Technical Service Bulletin

96 Lane change assist: side assist and exit warning system: unavailable. Sensor view restricted (DTC C12AA00)

96 24 99 2073683/2 June 21, 2024. Supersedes Technical Service Bulletin Group 91 number 24-01 dated April 16, 2024 for reasons listed below.

Model(s)	Year	VIN Range	Vehicle-Specific Equipment
RS 6 Avant	2021 - 2025	All	Not Applicable

Figure 1: Illustration showing positioning of holes for spreader rivets.

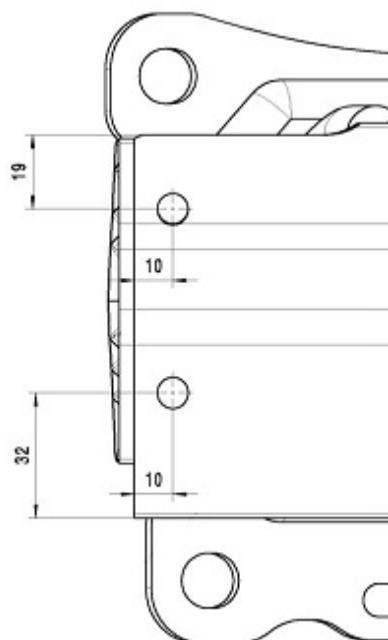
To secure the covers, two holes (8 mm diameter) must be drilled on each side (left and right) of the bumper cover, as shown in the image below:

Re Cover the holes and openings on both sides of the bumper carrier. To do so, please use the following covers:

Please use the following spreader rivet to secure the covers on the bumper carrier:
